Garrisons Lake Boat Ramp Reconstruction
DFW Contract No. NAT20001-Garrisons

Addendum 2: Question Responses and Drawing Revisions

GARRISON'S LAKE BOAT RAMP RECONSTRUCTION

C103

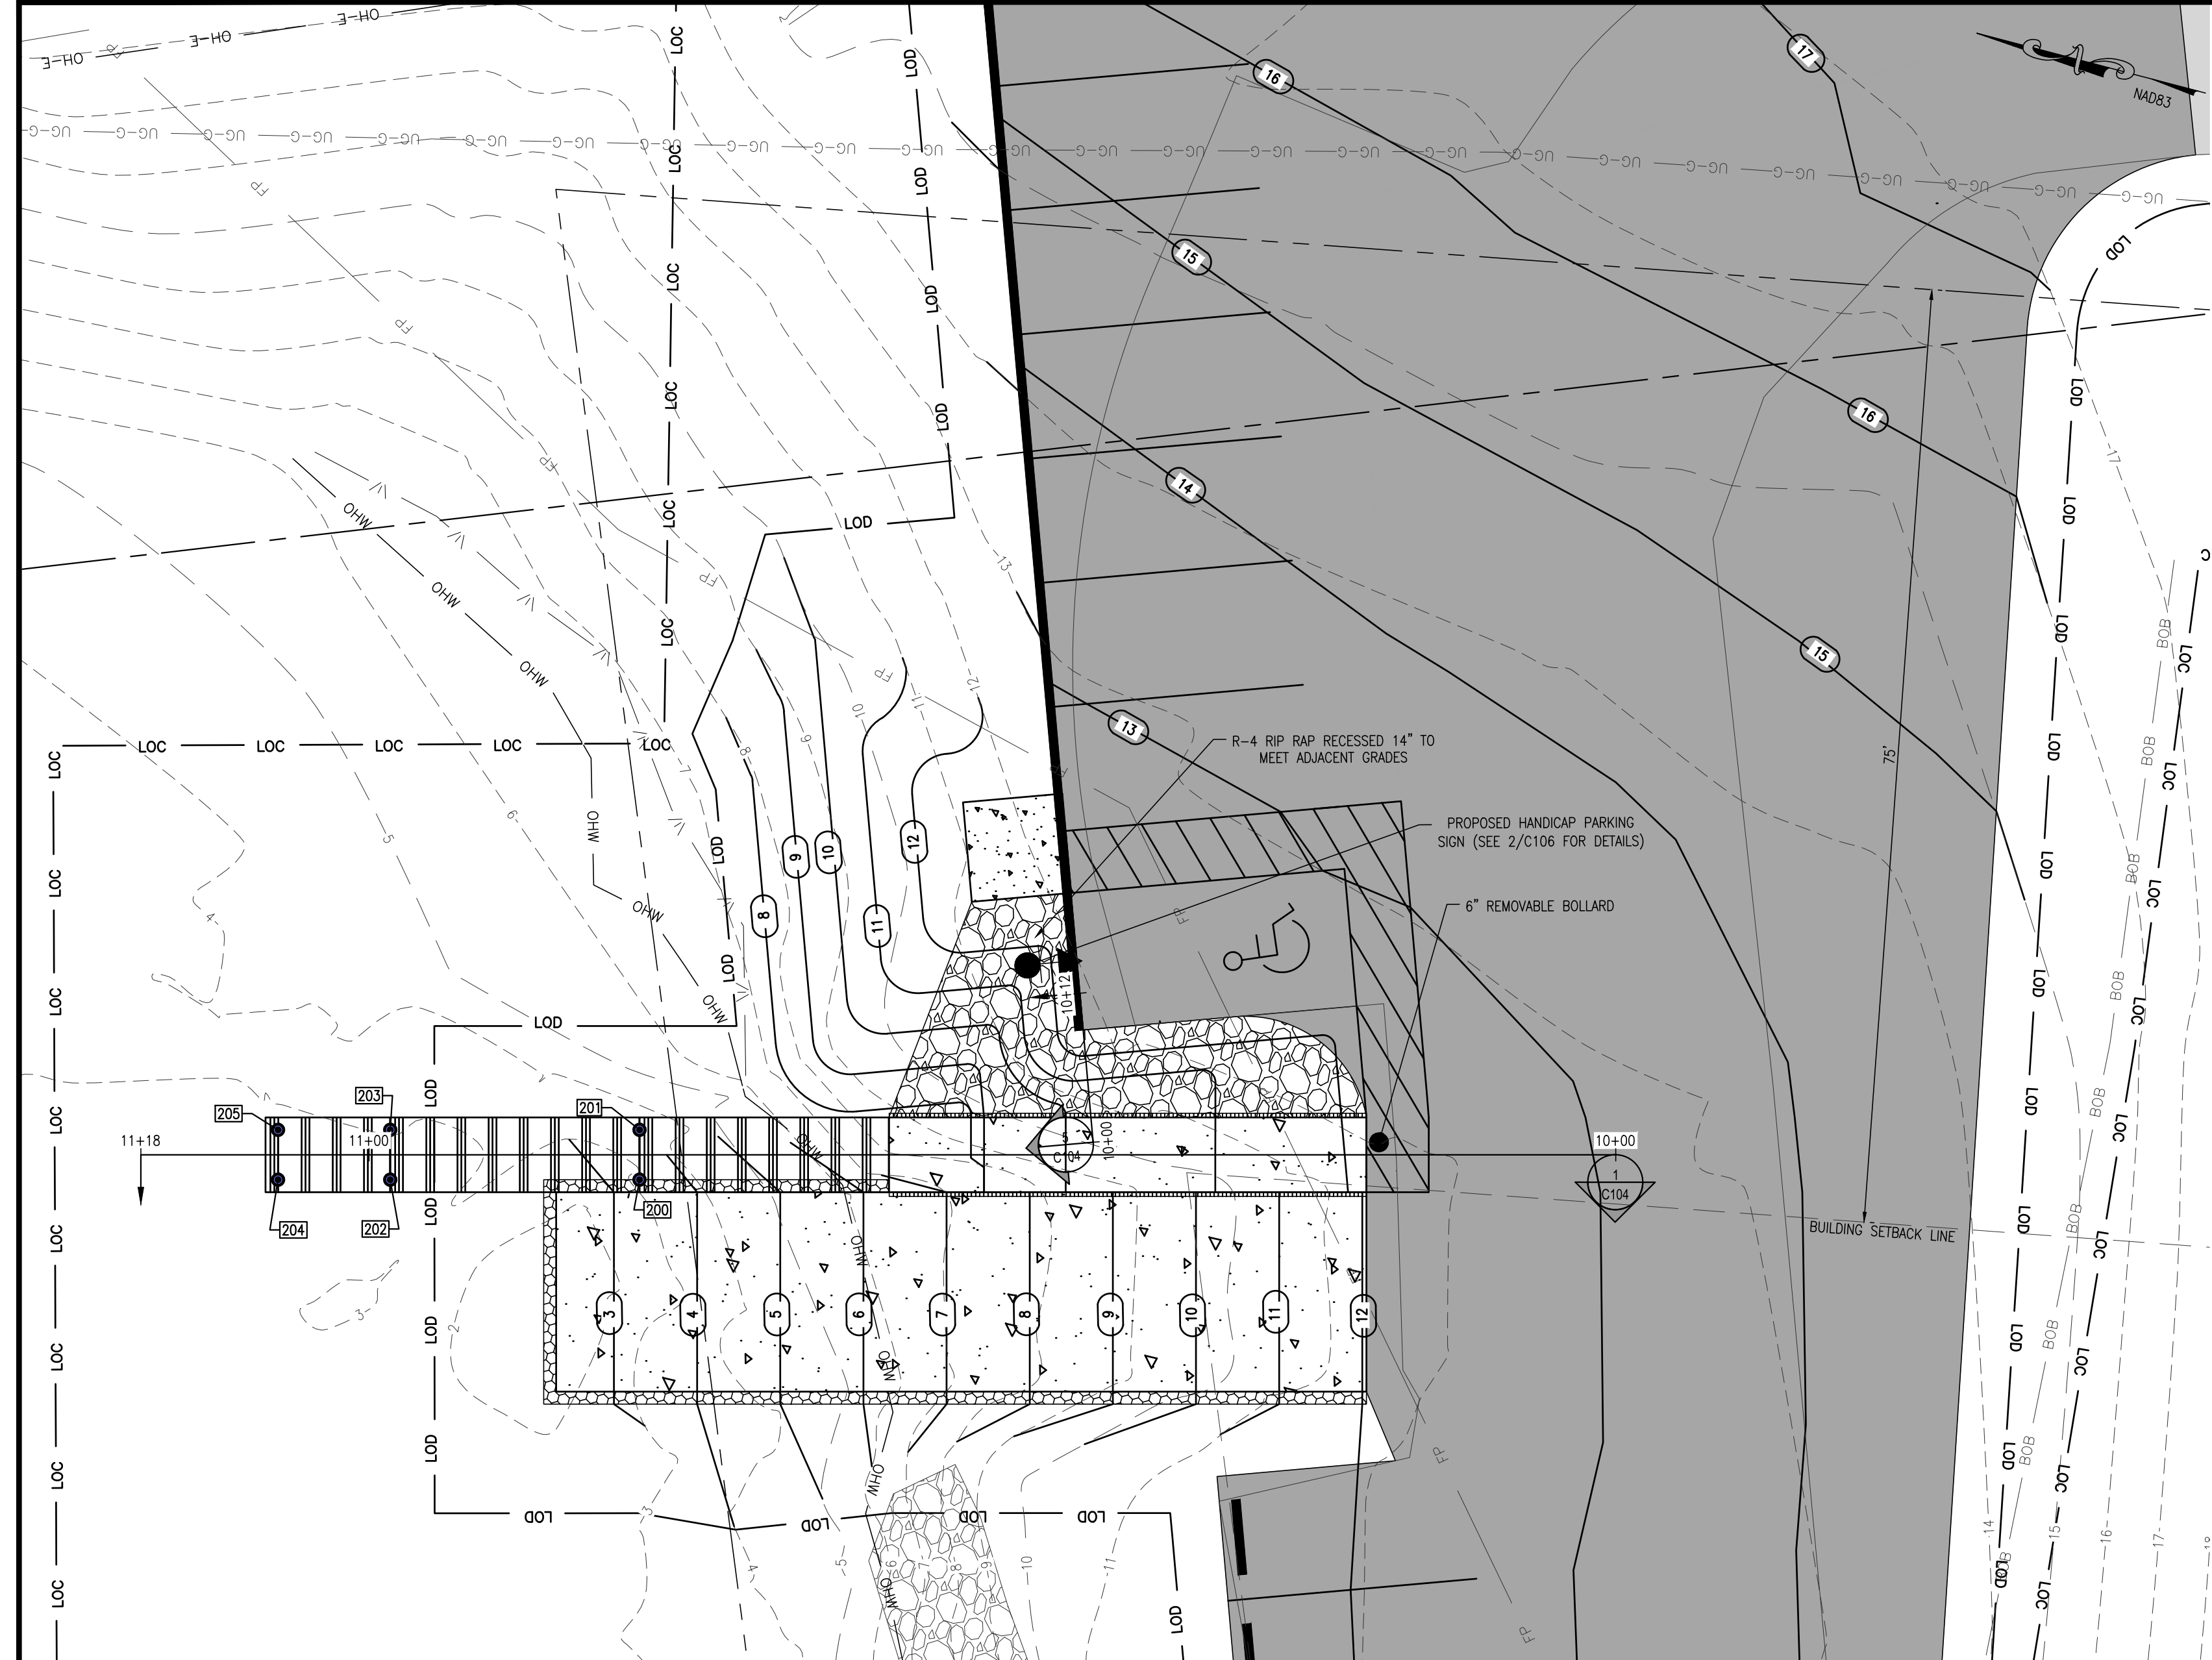
3. The plan view on C105 shows proposed grade lines beyond the LOD. Clearing and fill placement will be required to achieve these proposed grades. Do you want the grading as shown? If so, you will need to adjust the LOD and associated CFL placement.

- a. RESPONSE: Revised Construction Displays provided:
 - i. Sheet C103; Revision 2; Adjusted Compost Filter Log and Limit of Disturbance; 11-03-2020
 - ii. Sheet C104; Revision 1; Provided New Detail 5/C104; 11-03-2020

5 PROPOSED RIP RAP SECTION
SCALE: 1"=5'

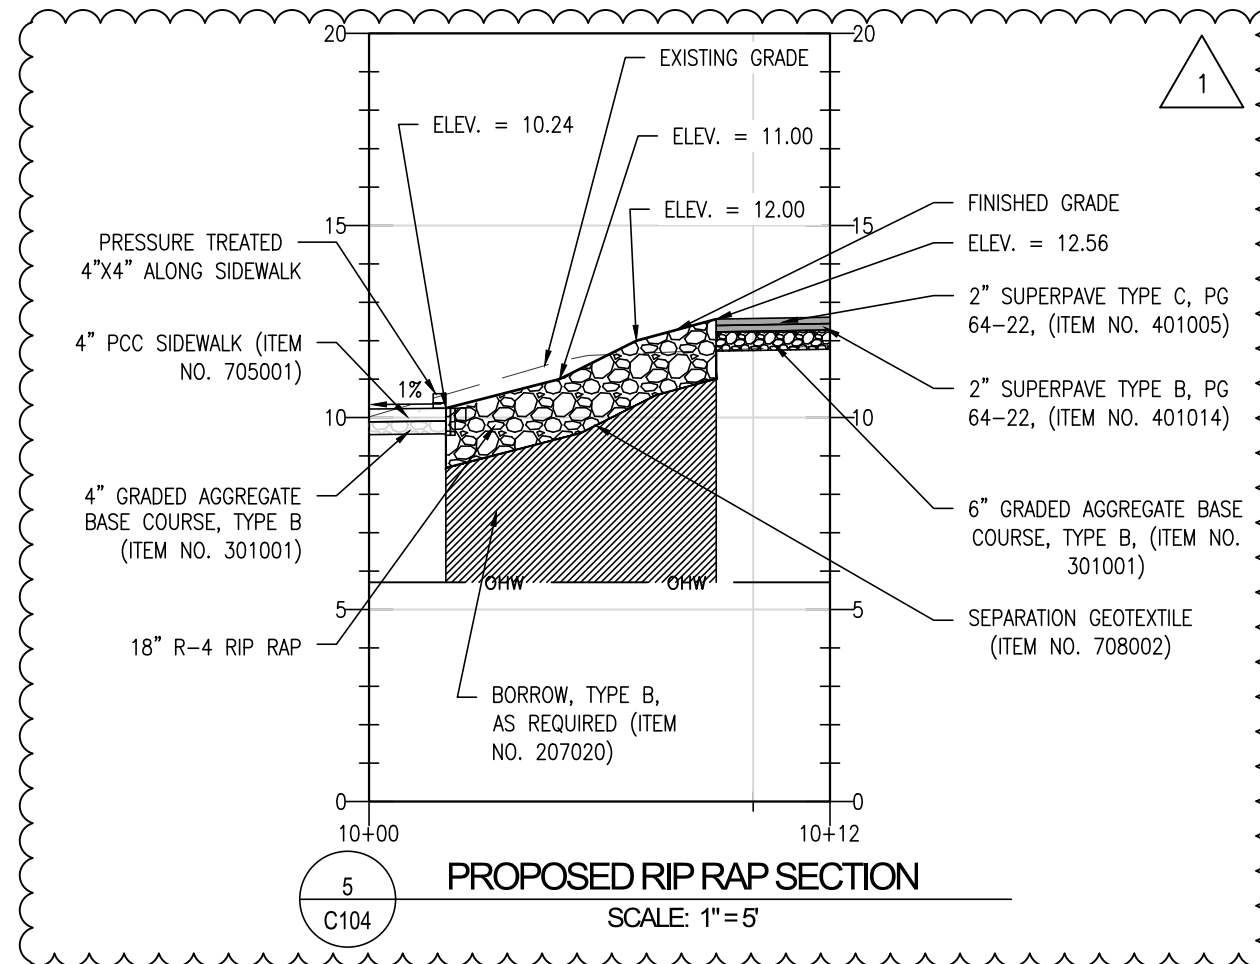
- iii. Sheet C104; Revision 1; Provided New Detail 5/C104; 11-03-2020
4. Section 5/104 shows riprap to be placed from proposed grade down to the OHW elevation. Do you want riprap placed down to the OHW elevation for all of the proposed riprap surface area shown? If so, riprap will be over 6' thick in places.

- a. RESPONSE: Revised Construction Displays provided:
 - i. Sheet C103; Revision 2; Adjusted Compost Filter Log and Limit of Disturbance; 11-03-2020

- ii. Sheet C104; Revision 1; Provided New Detail 5/C104; 11-03-2020
- iii. Sheet C104; Revision 1; Provided New Detail 5/C104; 11-03-2020

DESCRIPTION	DATE
PROVIDED NEW DETAIL 5/C104, 11/03/2020
